## Geotechnical Engineering Report

Meridian Circle K Retail Store  
Falcon, Colorado

November 30, 2018  
Terracon Project No. 23185069

PCD File VR-22-03

# EXPLORATION PLAN

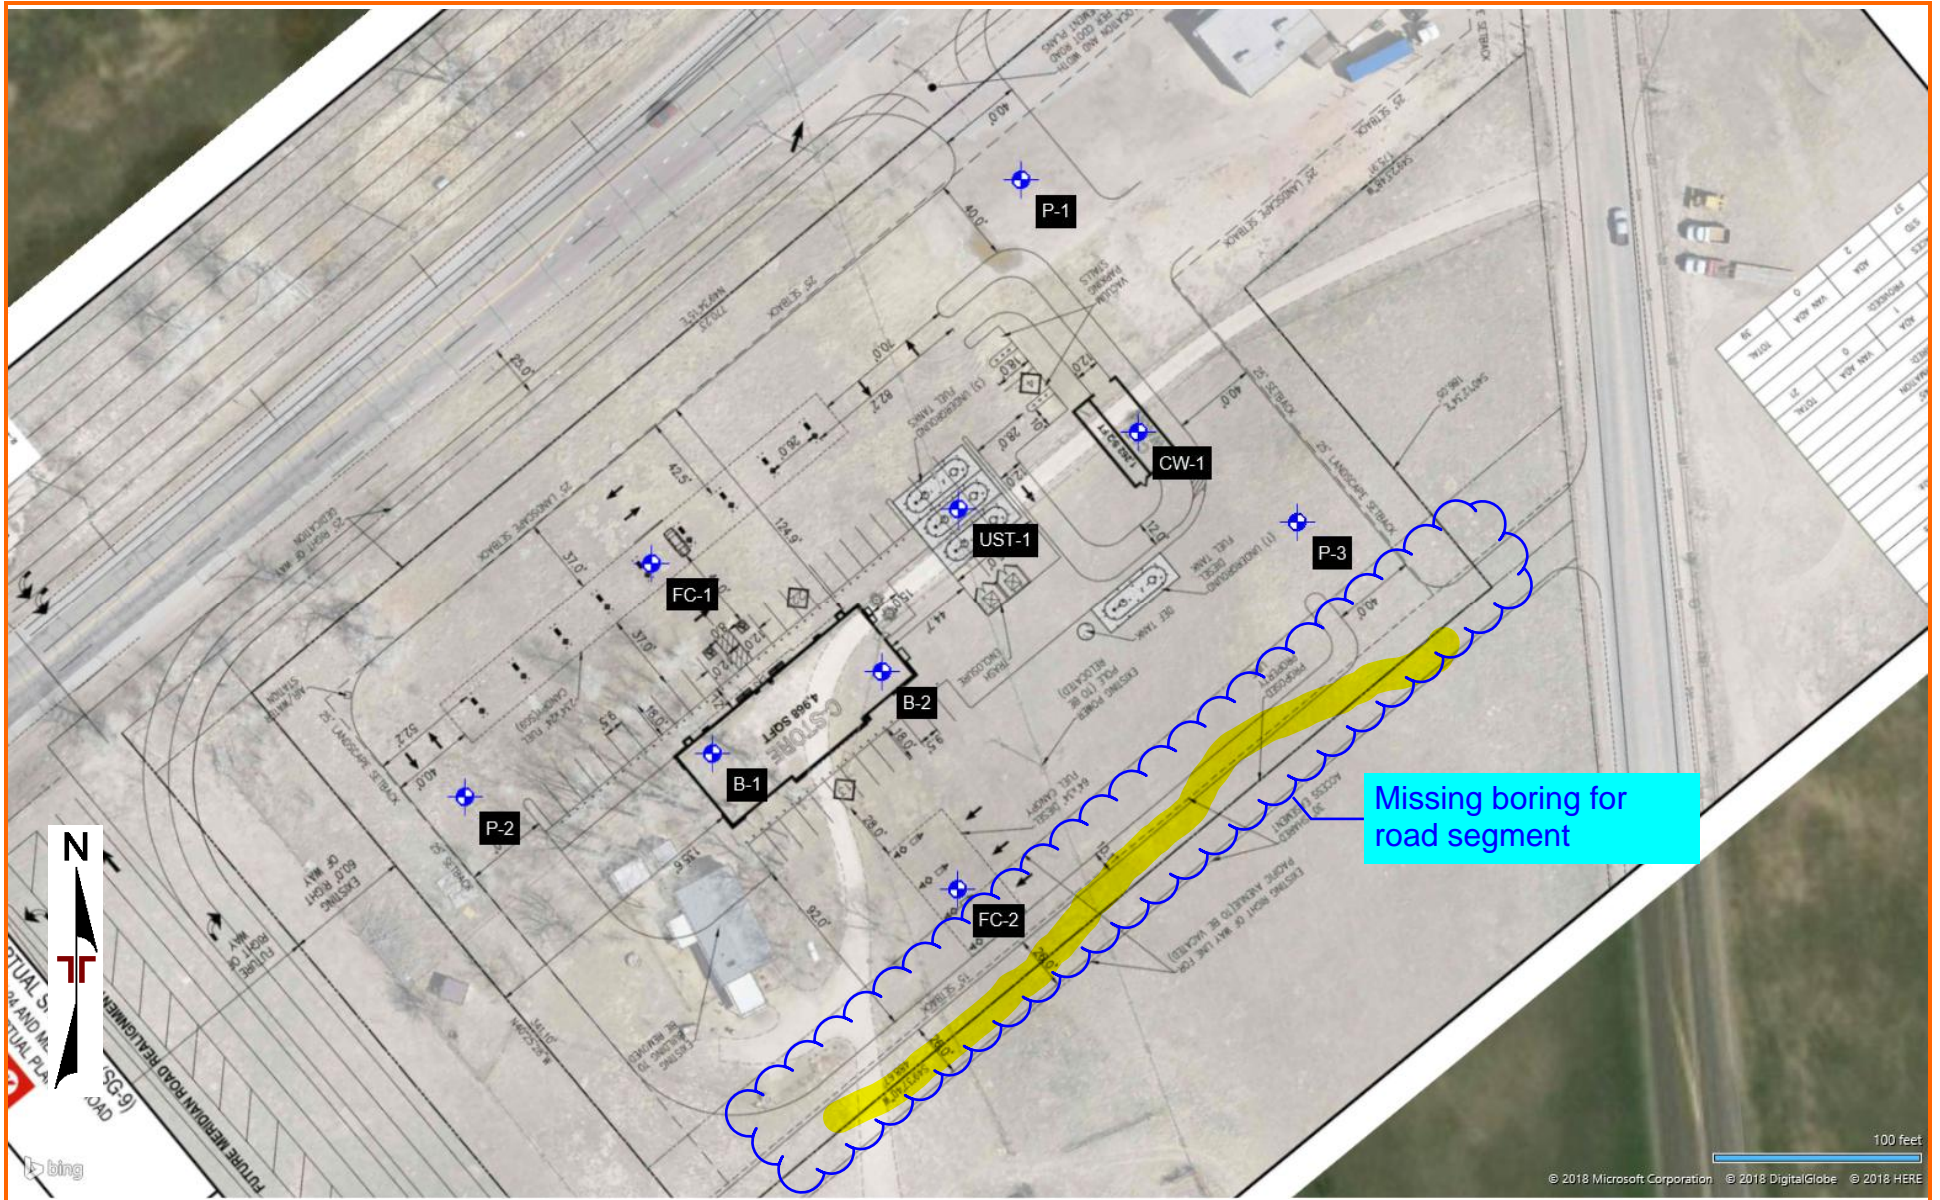
See notes below concerning borings

A. Timing of Soil Borings. 1. Initial Borings. The information from the initial soil borings shall be summarized in the Geotechnical Report. The entire site shall be sampled for initial testing. This is required to evaluate soil and groundwater conditions and for evaluating roadway locations that may not yet be determined or may change. 2. Structures. Soil borings for design of transportation structures shall be taken prior to the design of the structure. 3. Fill for Right-of-Way Grading. Testing shall be provided for all proposed fill material. All proposed fill material shall be approved by The ECM Administrator prior to placement. The material shall meet minimum requirements and be equal to or better than existing conditions. No fill material with a liquid limit greater than 40 and plasticity index greater than 20 shall be used in the upper 2-feet of the pavement subbase without implementing proper mitigation techniques.
